Public Comments and District Responses

From: Kristina Deak
To: Angel Martin
Cc: Lei Yang
Subject: RE: Upper Peace River Peer Review Kickoff Proposed Minimum Flows-Jan. 16, 2026
Date: Friday, January 16, 2026 1:54:00 PM

[EXTERNAL SENDER] Use caution before opening.
Concerning the subject Upper Peace River proposed minimum flows kickoff meeting, the following summarize my comments.

Figure 6-6. Annual exceedance flow for the USGS Peace River gage at Fort Meade for the periods 1975-2022, comparing baseline and gaged flows in relation to the low flow threshold.

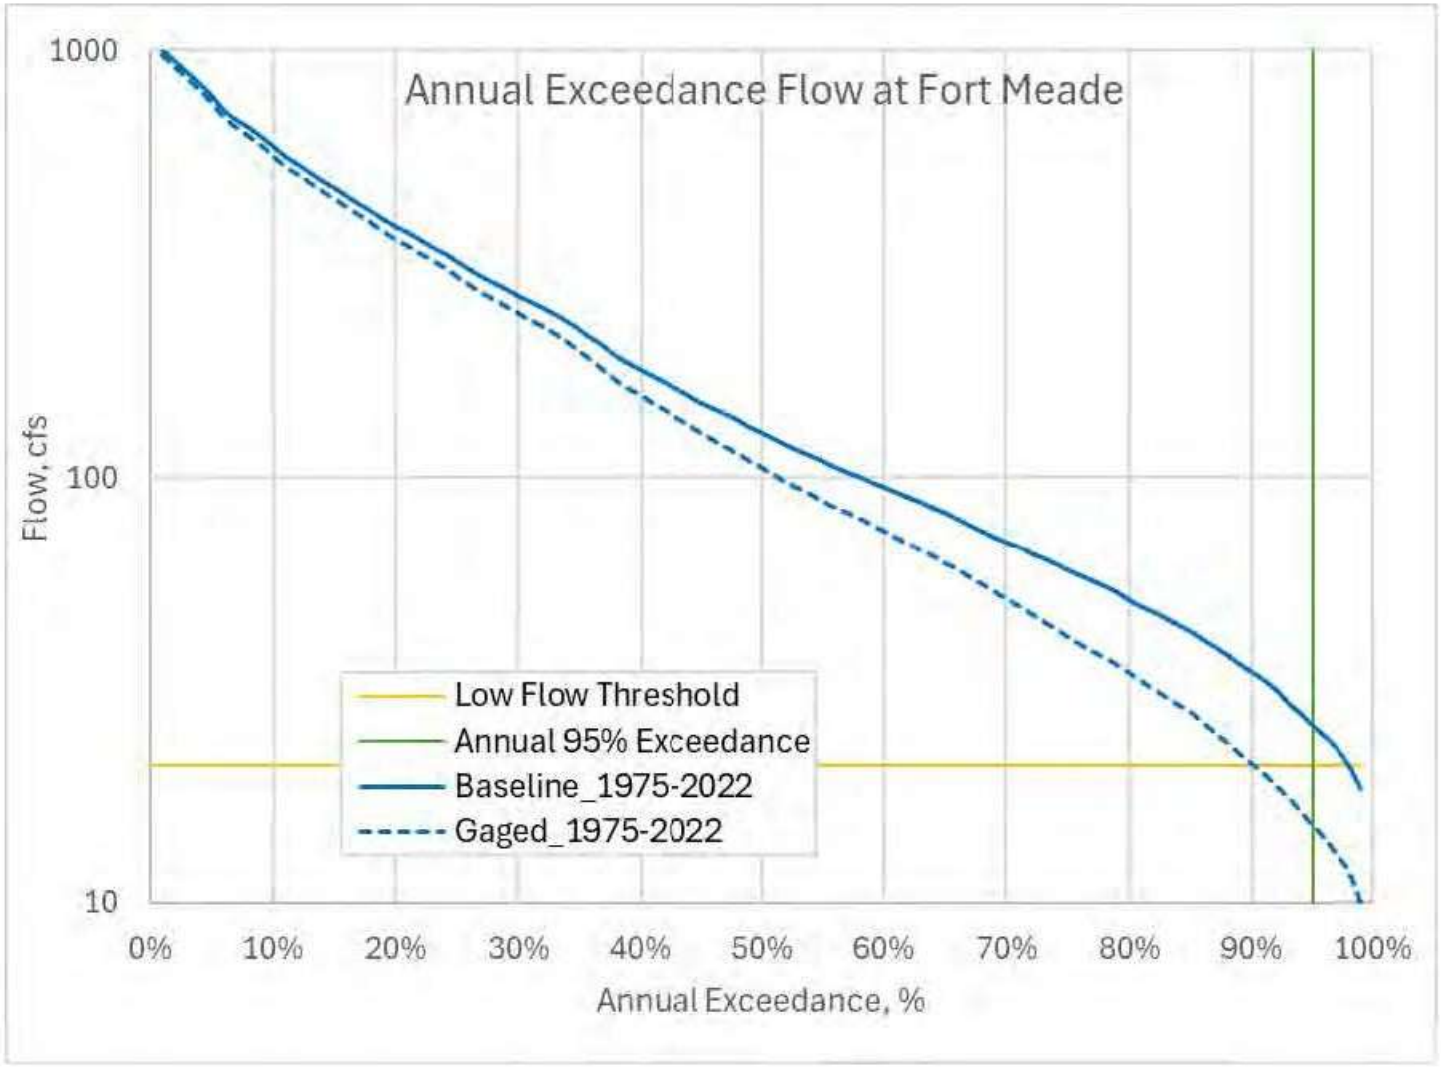
Other useful graphics in the draft District report are flow duration curves for baseline flows and gaged flows. Figure 6-6 for the Ft. Meade gage taken from the District report is shown below. The Y axis is on a semi-log scale, so additional tic marks and cross hatching in the figure would be helpful to identify the flow quantities. However, for much of the flow range it appears that gaged flows are less than the baseline flows by amounts exceeding the percentages allowed by the proposed minimum flows. In my final review of the report, I am going to request that the scale for the Y axis in this figure be improved and flow percentiles values for these two flow scenarios be reported in a table in 5 percentile increments.

Figure 1. Median daily flows for the baseline flows and the gaged flows for the Peace River at Ft. Meade gage calculated for the years 1975-2022. Taken from Figure 5-9 in the draft District report.

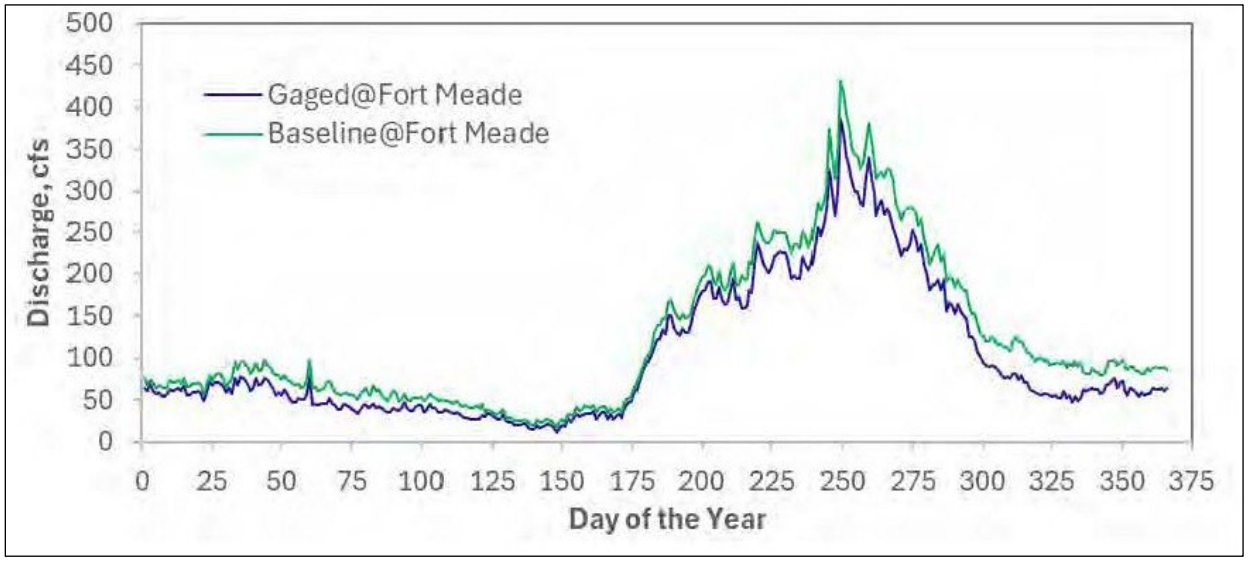
The District report provides some useful graphics of the modeled baseline flows versus the gaged flow records for the river that are helpful for assessing this question. A hydrograph for the Ft. Meade gage taken from Figure 5-9 in the draft District report is reprinted below, showing median flow values for each day of the year for both the modeled baseline flows and the gaged flows for the river at that gage.

Figure 1. Median daily flows for the baseline flows and the gaged flows for the Peace River at Ft. Meade gage calculated for the years 1975-2022. Taken from Figure 5-9 in the draft District report.

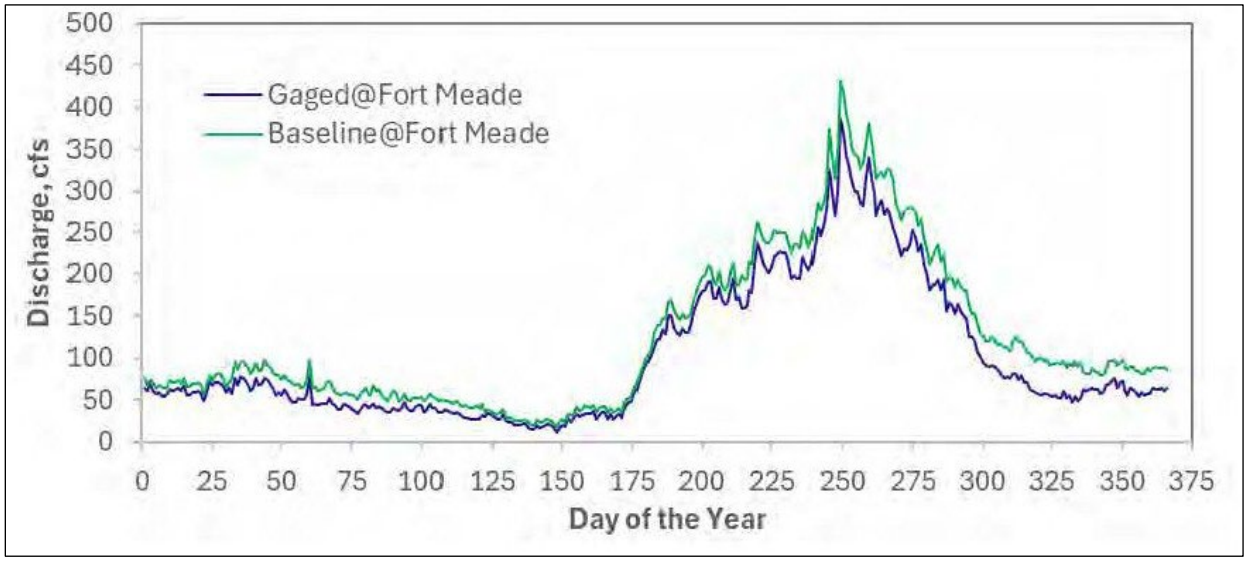
The District report does provide some useful graphics of the modeled baseline flows versus the gaged flow records for the river that are helpful for assessing this question. A hydrograph for the Ft. Meade gage taken from Figure 5-9 in the draft District report is reprinted below, showing median flow values for each day of the year for both the modeled baseline flows and the gaged flows for the river at that site.

Figure 1. Median daily flows for the baseline flows and the gaged flows for the Peace River at Ft. Meade gage calculated for the years 1975-2022. Taken from Figure 5-9 in the draft District report.

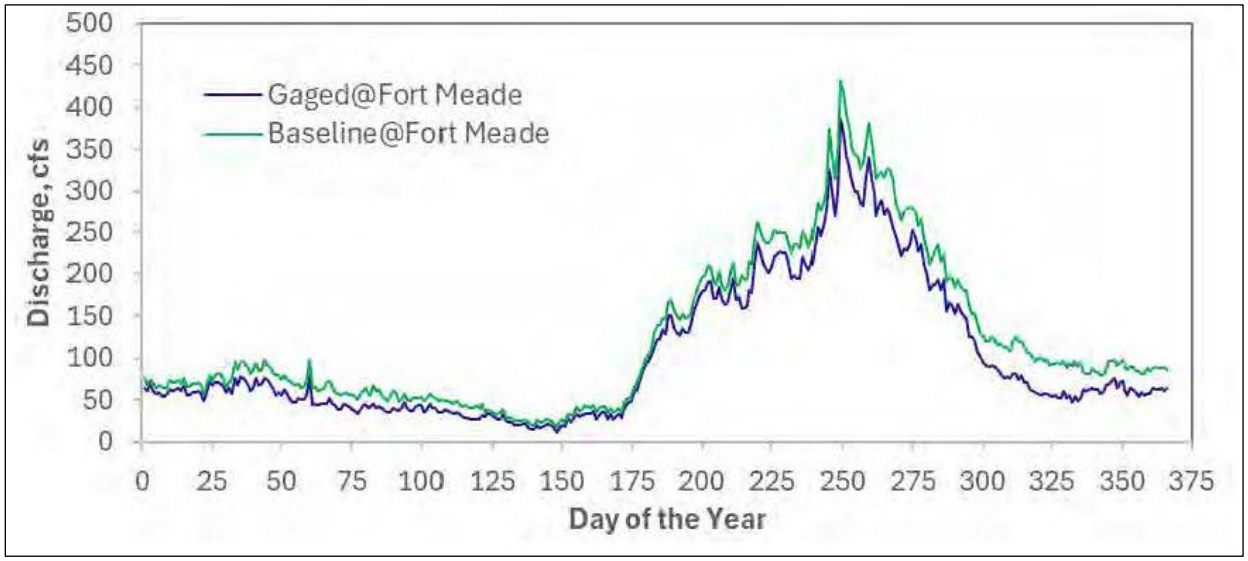
The District report does provide some useful graphics of the modeled baseline flows versus the gaged flow records for the river that are helpful for assessing this question. A hydrograph for the Ft. Meade gage taken from Figure 5-9 in the draft District report is reprinted below, showing median flow values for each day of the year for both the modeled baseline flows and the gaged flows for the river at that site.
